RE: TR-121883 - A Street Crossing in Auburn - Signage and vegetation

Commission Staff met with staff from the City of Auburn (City) today regarding the conditions in the Commission's order in TR-121883, Order 01 issued on December 13, 2012:

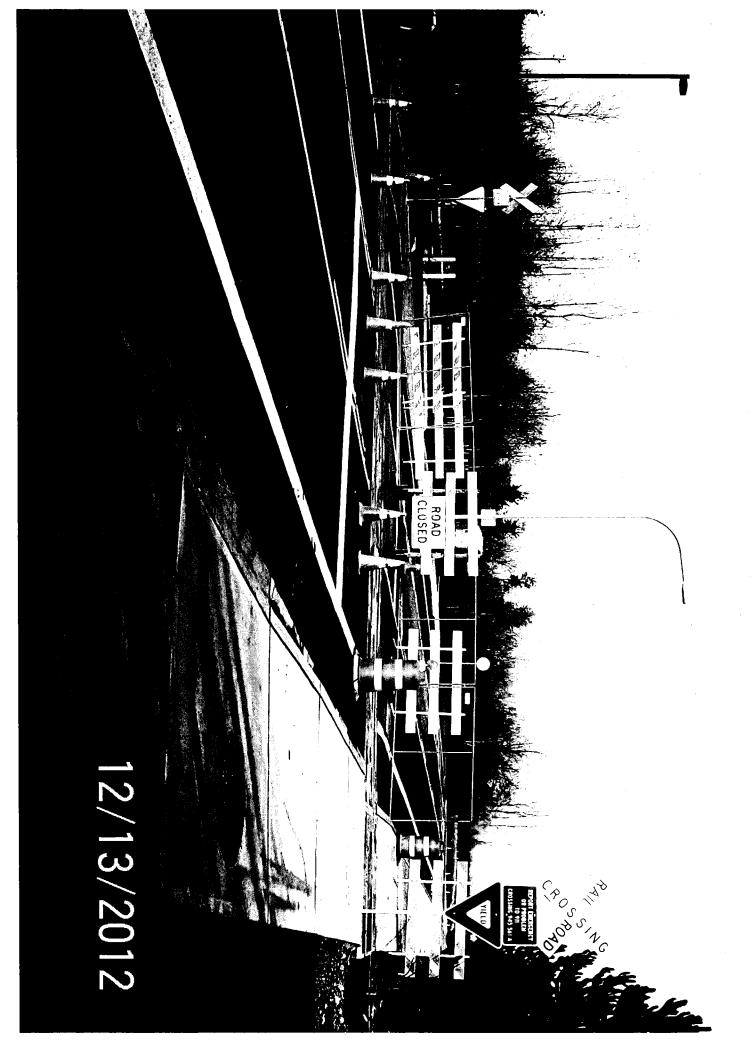
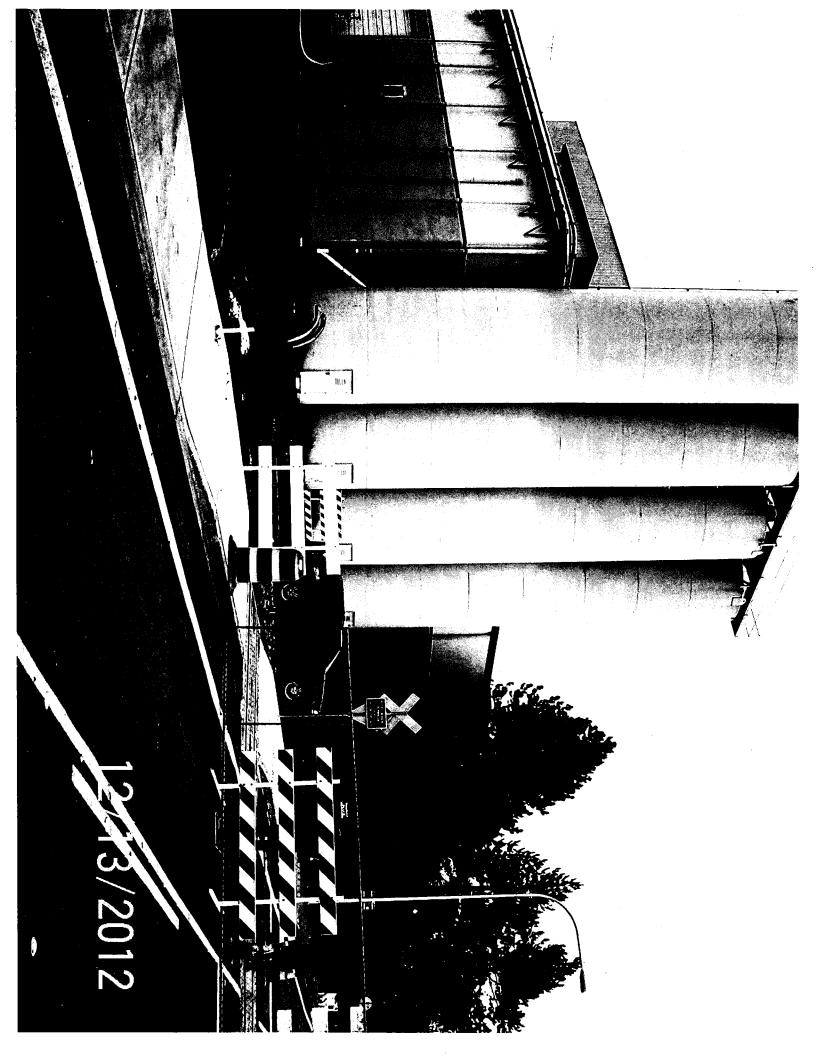
The Petitioner must remove vegetation in all quadrants of the crossing to maximize sight distance for motorists prior to the Petitioner reopening the roadway.

I am enclosing "before" and "after" pictures of the crossing. These pictures show that the City has complied with the UTC staff's direction regarding sightlines at the crossing.

Results: Verified per the attached photos.
